RESPONSE TO BRISBANE CITY COUNCIL INFORMATION REQUEST: S.13 OF THE DEVELOPMENT ASSESSMENT RULES

DEVELOPMENT PERMIT FOR MATERIAL CHANGE OF USE FOR AN INDOOR SPORT AND RECREATION AT 25 NAVIGATOR PLACE, HENDRA (LOT 7 SP107065)

COUNCIL REFERENCE: A007037587

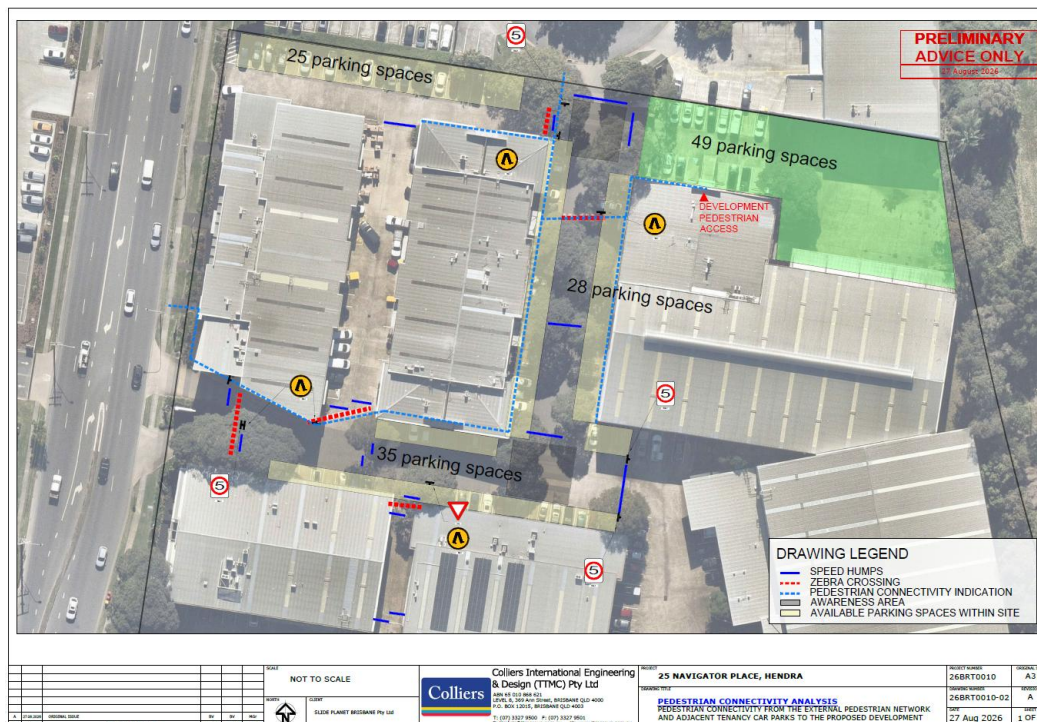
- 2) *Council has reviewed the proposal and calculated the parking rate based on 4 courts and 2795sqm of GFA indicating a shortfall of 103 carparking spaces during peak times. The reliance on on-street carparking cannot be taken into consideration when calculating the available carparking spaces, therefore the use will be reliant on the availability of parking spaces within the subject site. Further documentation is required to demonstrate the full availability of carparking spaces during business hours, after hours, and the weekend.*

The proposed use will introduce a significant number of vulnerable pedestrians, typically not expected within an established 'industrial park'. There is concern about pedestrian interaction with vehicles through the site and from Navigator Place.

- a) *Provide an RPEQ traffic response demonstrating how pedestrian access can be achieved safely and efficiently throughout the site.*

An updated traffic response has been prepared by Colliers and provided in **Appendix C**. Reference should be made to Appendix C for the full response provided to item 2 for car parking and pedestrian access.

The response provides a copy of the letter provided by the site owner confirming that the site is a multi-tenanted facility which is supported by shared on-site parking facilities which can be utilised by occupants and visitors of the complex and are utilised on a shared, non-exclusive basis. Therefore, as shown in **Appendix C**, in addition to the 49 car parking spaces provided adjacent to the proposal, a further 88 car parking spaces are available within proximity of the proposal (contained wholly on site of Lot 7 on SP107065).

Therefore, the proposal is supported by a total of **137** car parking spaces on site.

The plan which outlines the additional car parking spaces also demonstrates the existing traffic calming techniques utilised across the site including speed humps, zebra crossings, regulatory signage and pavement awareness treatments. An extract of this plan has been provided below (**Figure 8**), however reference should be made to **Appendix C** for the full response in relation to Item 2.

Figure 9: Extract from site plan, total refuse area outlined in blue and of Proposed Northern Elevation showing existing screening (Source: Base architecture and interiors, 2026)

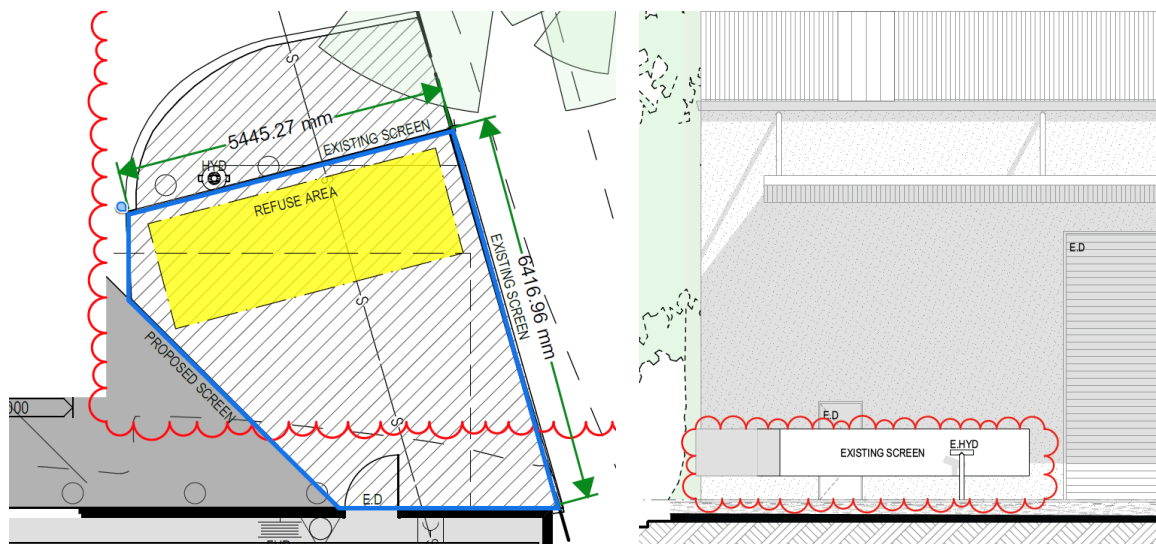
- 3) A refuse storage area with sufficient capacity is required to be demonstrated in accordance with AO1.5/PO1 of the Indoor sport and recreation code, AO17.2/PO17 of the Industry code and AO8.1 & AO8.2 of the Infrastructure design code.
- a) Demonstrate and identify a refuse storage area with a minimum internal size of 27.38 (7,500mm x 360mm). Note: dimensions to be clearly shown on plans.
 - b) Demonstrate the refuse storage area is house either within a building or roofed and screened enclosers. Where screening is utilised to form part or all of a refuse storage area, screening is to have a maximum of 25% openings, with a maximum opening dimension of 50mm, and are to be permanently fixed, durable and maintainable. Note: the refuse storage area is to be located within 5 metres of the collection location.

- a) Demonstrate and identify a refuse storage area with a minimum internal size of 27.38 (7,500mm x 360mm). Note: dimensions to be clearly shown on plans.
- b) Demonstrate the refuse storage area is house either within a building or roofed and screened enclosures. Where screening is utilised to form part or all of a refuse storage area, screening is to have a maximum of 25% openings, with a maximum opening dimension of 50mm, and are to be permanently fixed, durable and maintainable. Note: the refuse storage area is to be located within 5 metres of the collection location.

- b) Demonstrate the refuse storage area is house either within a building or roofed and screened enclosures. Where screening is utilised to form part or all of a refuse storage area, screening is to have a maximum of 25% openings, with a maximum opening dimension of 50mm, and are to be permanently fixed, durable and maintainable. Note: the refuse storage area is to be located within 5 metres of the collection location.

In response to item 3, a dedicated refuse storage area has been provided on the eastern side of the outdoor hardstand area and has an internal area of 28.6m², therefore achieving the specified minimum internal area of 27.38m² (**Figure 9**).

The refuse area is already benefitted by existing screening along the northern and eastern façade and additional screening to the west is proposed. The additional screening will ensure adequate amenity for on site users while maintaining a practical servicing outcome on site. Refer to **Figure 9** which provides an extract from the amended Architectural Plans (**Appendix C**). The details of the proposed screens are to be determined during the detailed design phase of the project, however, will comply with the abovementioned requirements of the City Plan, and these can be included as part of a reasonable and relevant condition of a decision package.

The proposal provides a clearly designated refuse storage area, which achieves the minimum internal space requirements as demonstrated above. The refuse area is already provided with screening, however, as outlined on the proposed plans additional screening is proposed to further protect the amenity of site users.
